PROJECT NO. ST87600114-3 GRAND CANAL BIKE AND PEDESTRIAN IMPROVEMENTS FEDERAL AID NO. PHX-0(BFG)F

ADDENDUM NO. 7

ISSUE DATE: October 4, 2017

DES: JL DR: JKA CK: RCA SHEET TOTAL DATE: 07/17 DATE: 07/17 NO: SHEETS
SCALE: 2.003 2.182

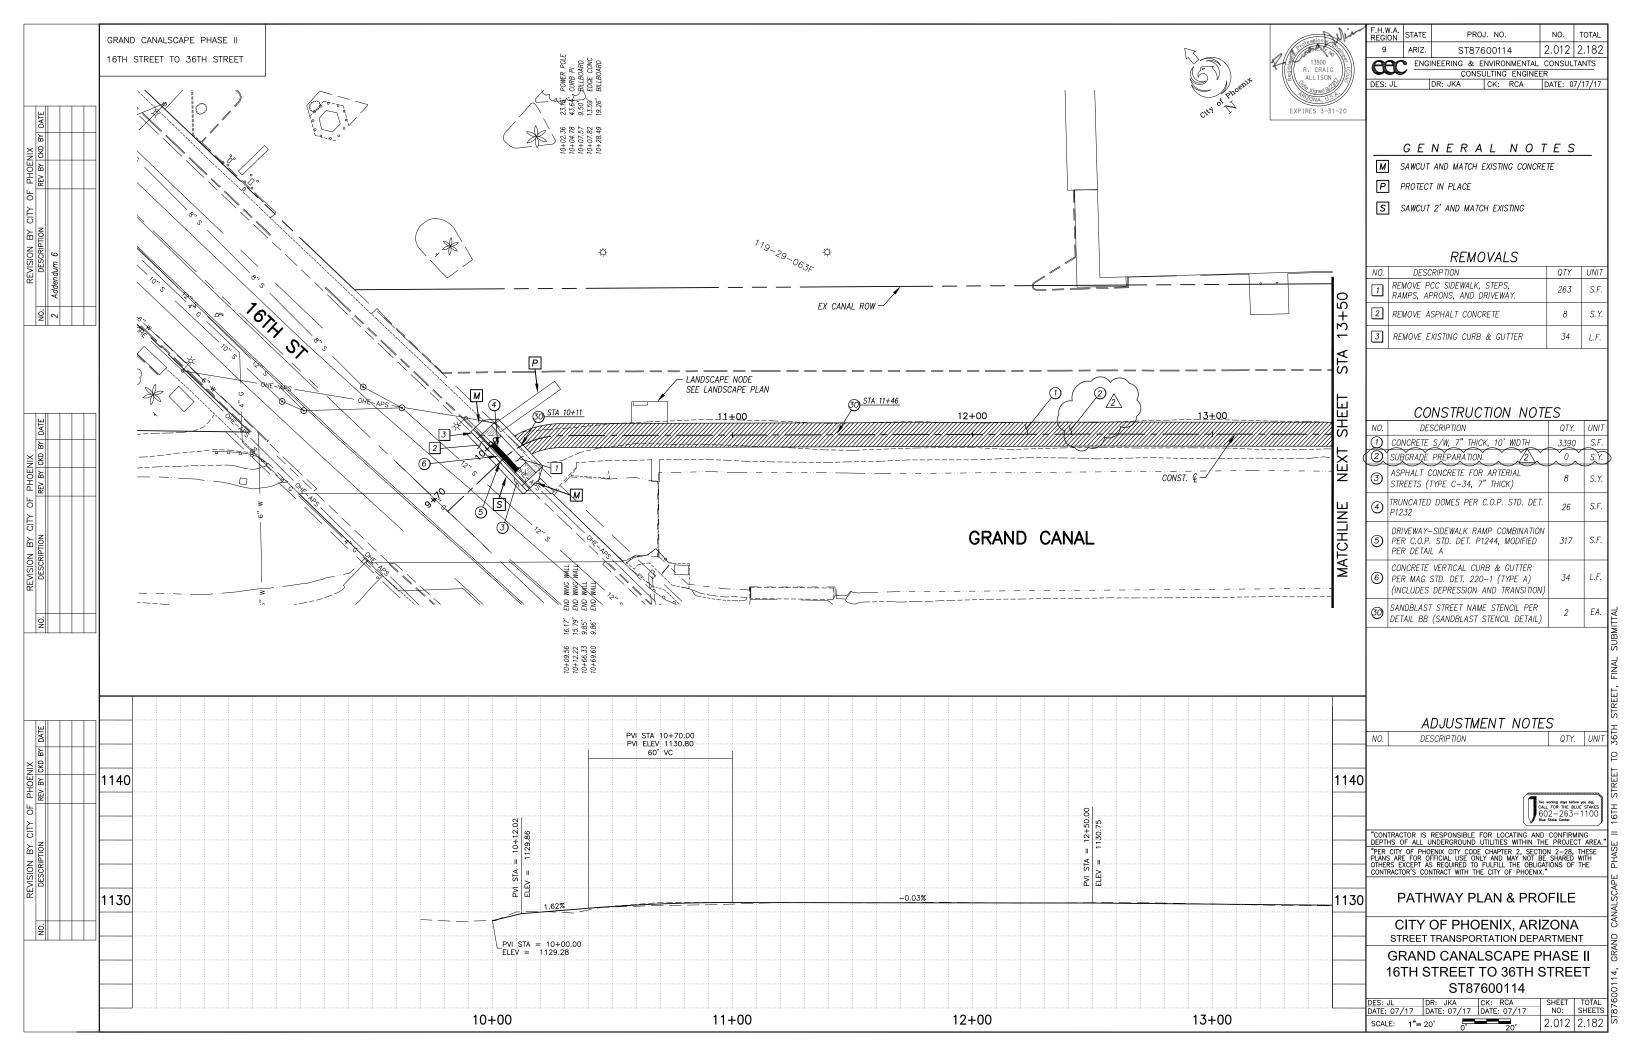
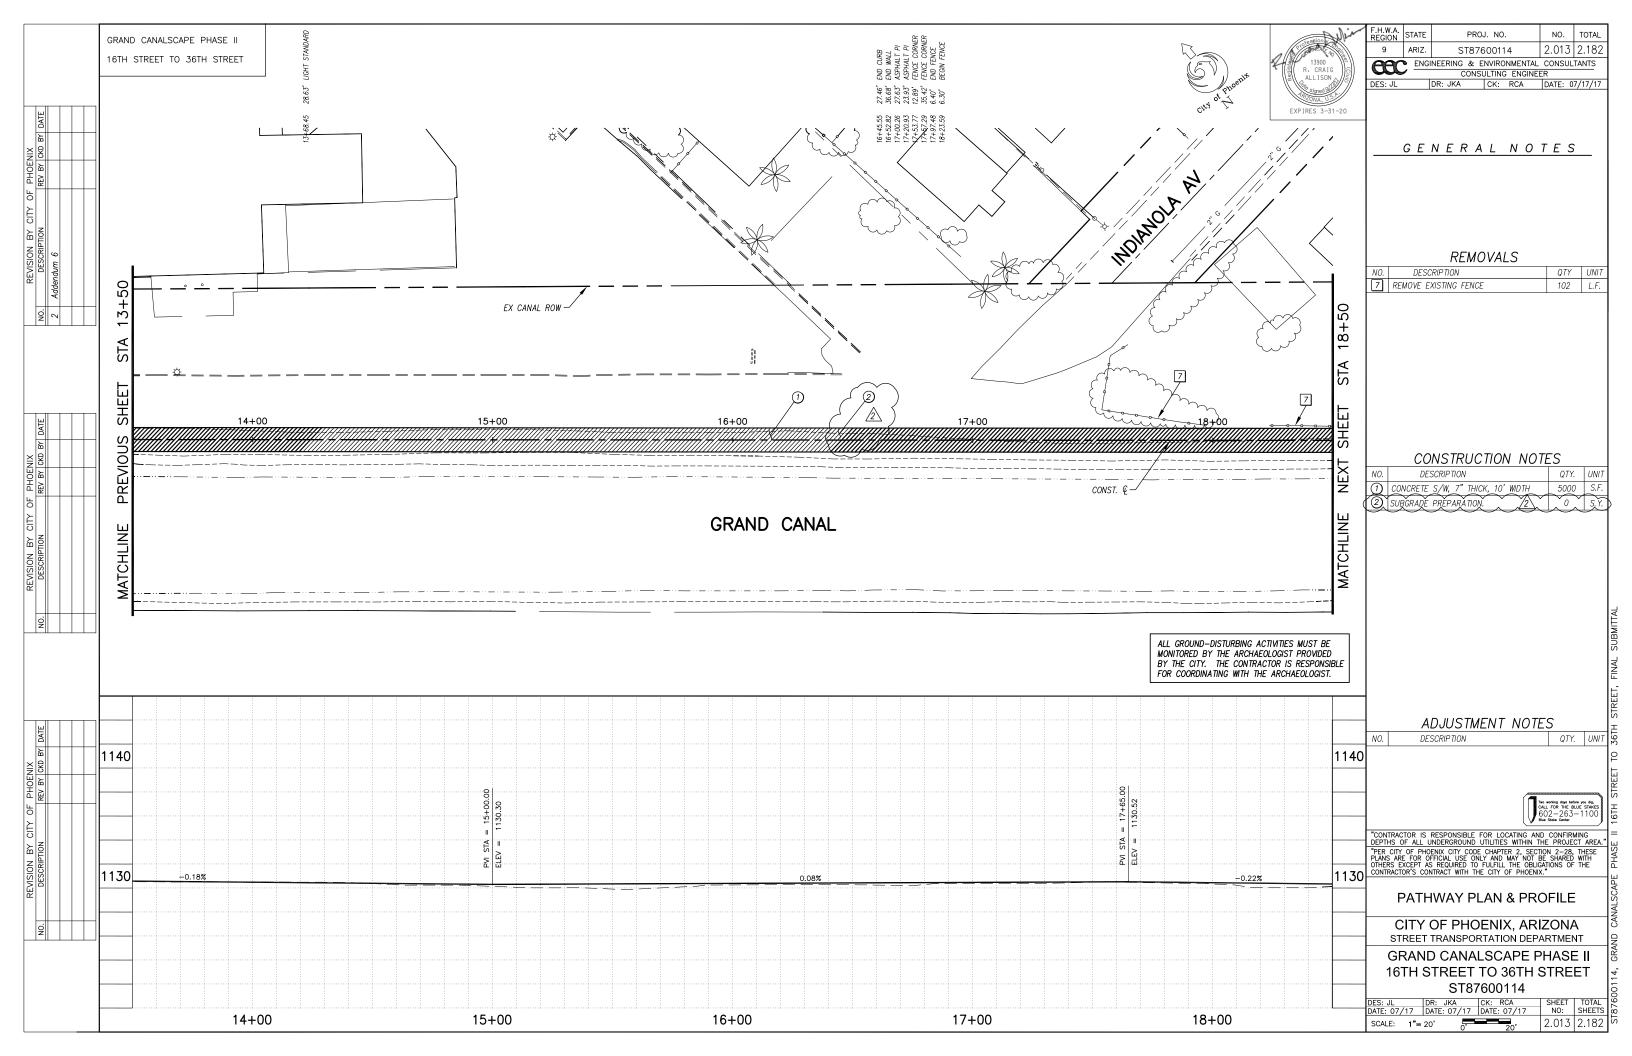
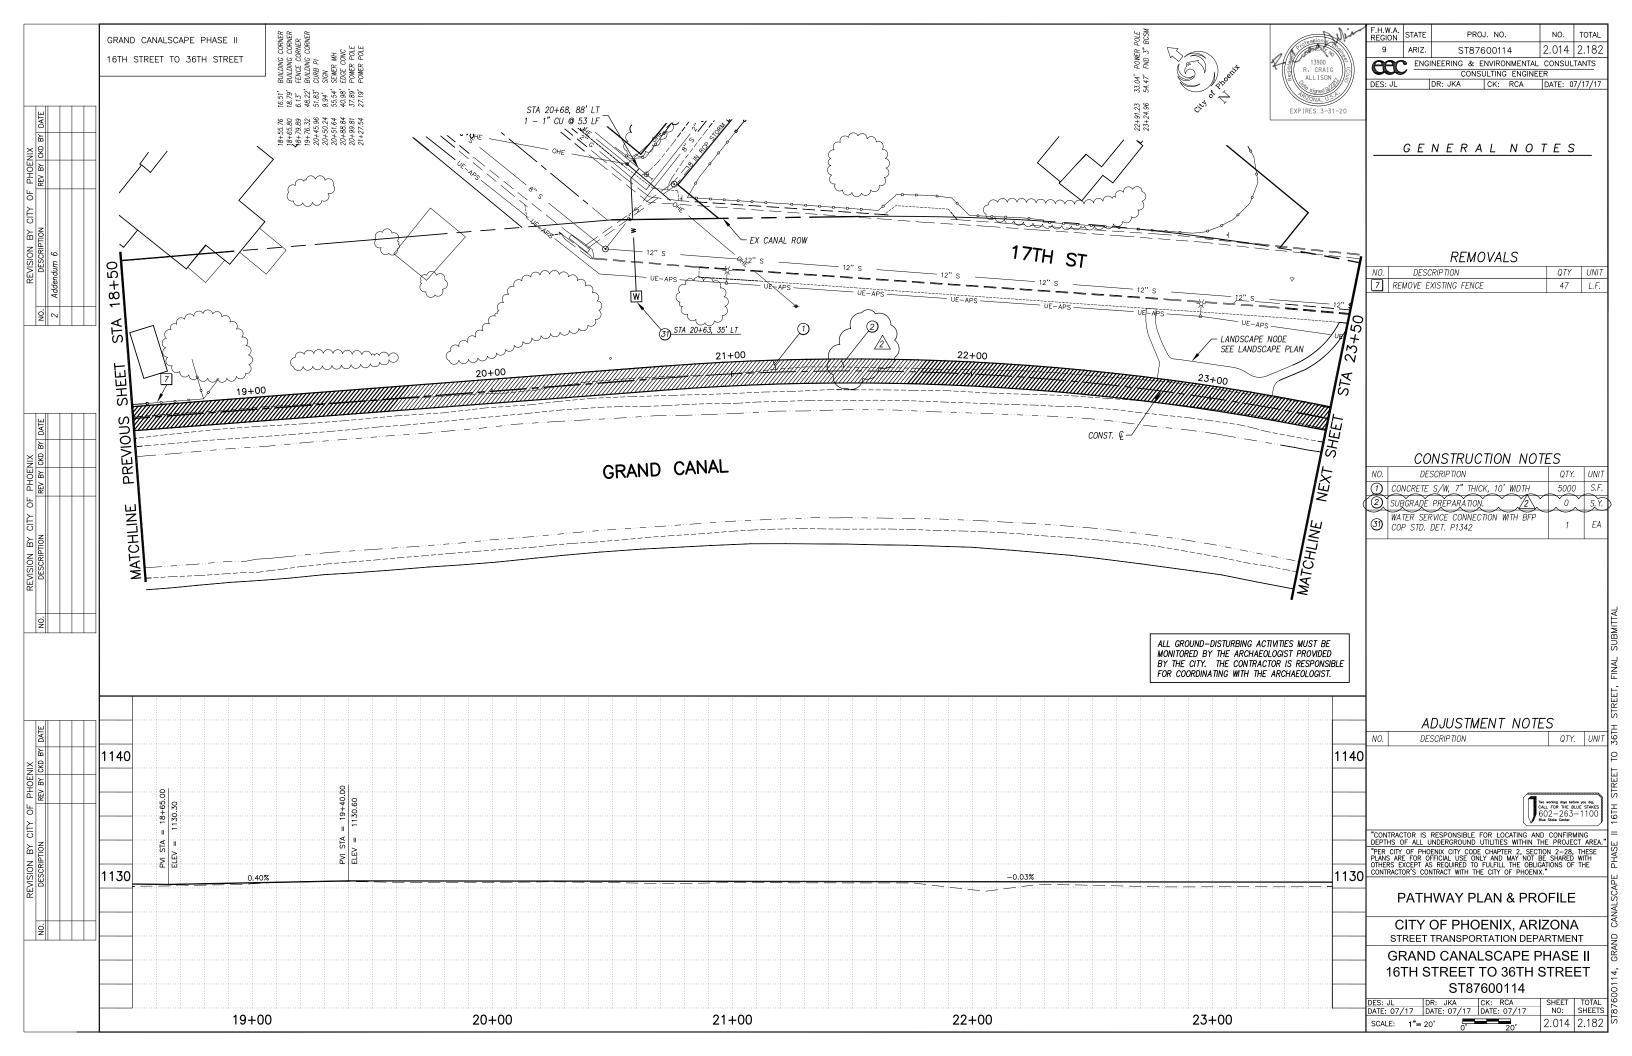
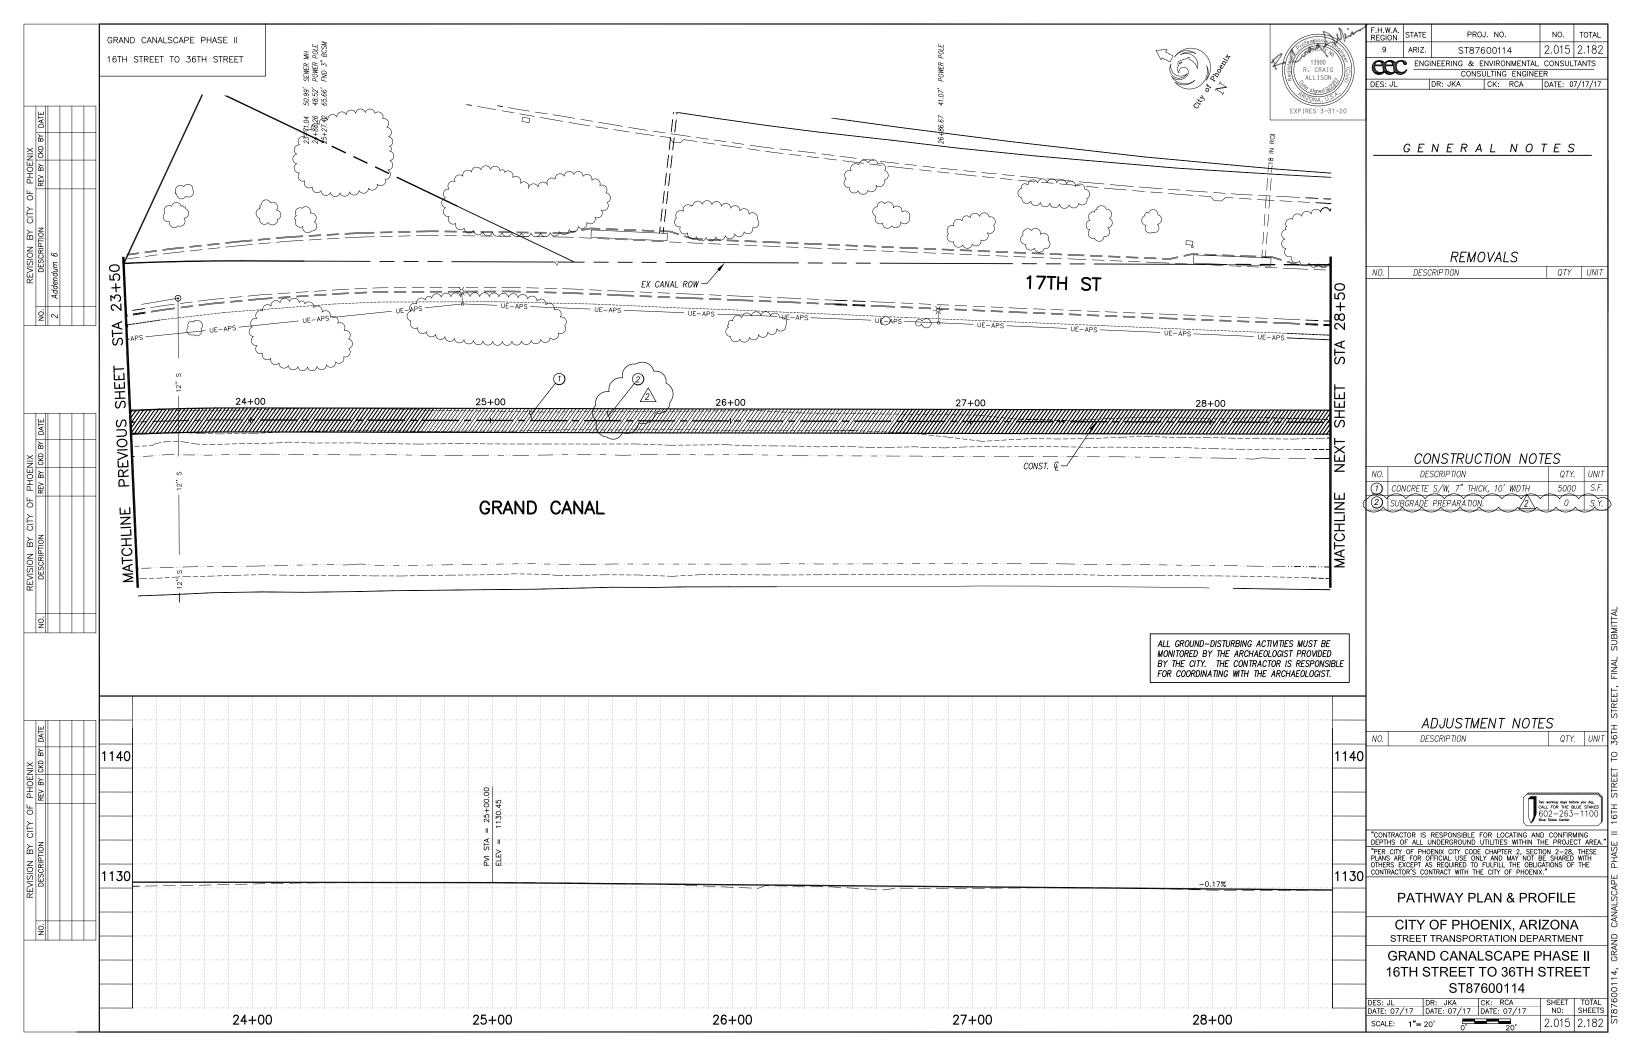
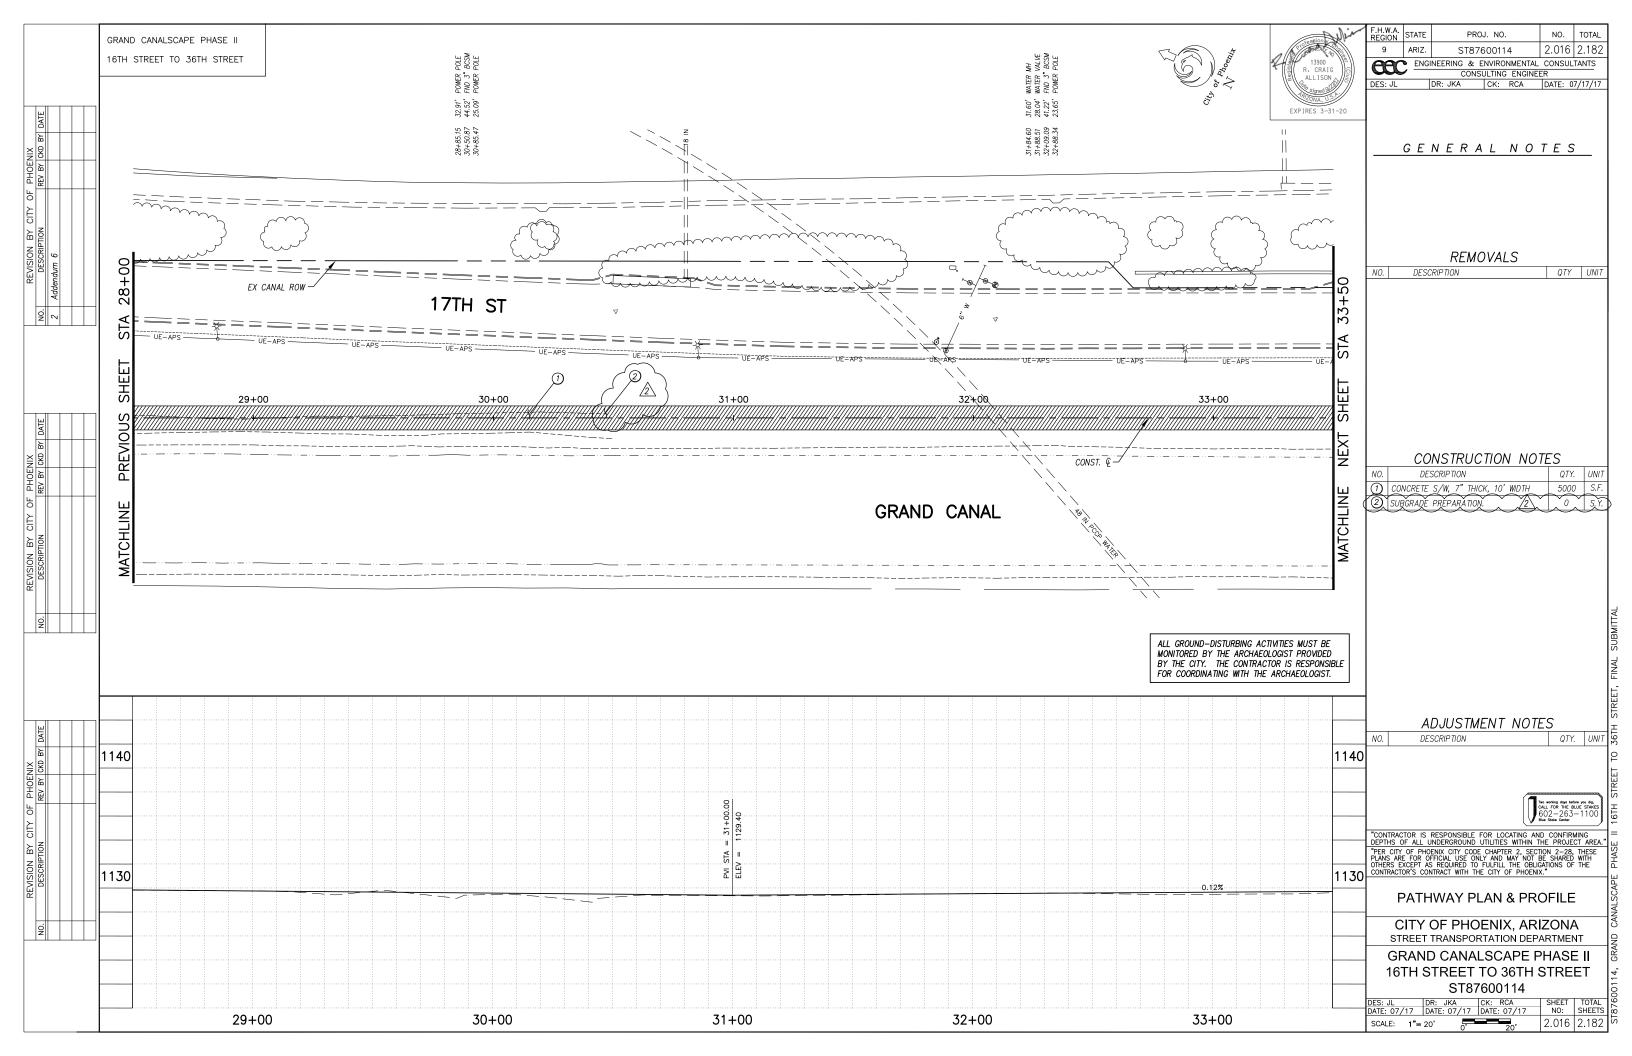
on 16th street to 26th street description call out WWF per detail. Detail on sheet 2.005
A21.	does not show any WWF. See response to Q12 in Addendum 5.
AZI.	See response to Q12 in Addendant 5.
Q22.	Have there been "laydown" area(s) designated for the (3) sections of work?
A22.	It is the responsibility of the contractor to find his own laydown areas.
	, , , , , , , , , , , , , , , , , , ,
Q23.	Will there be a site visit scheduled for each of the sections?
A23.	A site visit for all three segments was held on September 21 per Addendum # 3.
004	Dona this against house a Construction Display Display
Q24. A24.	Does this project have a Construction Phasing Plan?
A24.	No, it is the responsibility of the contractor to provide a phasing plan. Contractor will be required to comply with Traffic Specifications and the Traffic Barricade Manual.
Q25.	Plans show drive approach Detail P-1244 Modified. Bid Schedule does not list P-1244. Please advise how we should bid this item.

- 1. Replace sheet 2.003 with Sheet 2.003 REV.
- 2. Replace sheets 2.012 to 2.052 with Sheets 2.012 to 2.052 REV.
- 3. Replace landscape sheets 1.29; 2.101; and 3.52 with revised sheets 1.29; 2.101 and 3.52 REV 10/2/2017 (revisions to post fence detail/schedule).
- 4. Replace landscape sheets 2.127 and 3.68 with 2.127 and 3.68 REV 10/2/2017 (revisions to landscape legend).
- 5. An entire legible set of Segment 2 landscape sheets are attached. Revised Segment 2 sheets for post fence and landscape legend are included in entire legible set of Segment 2 landscape sheets.
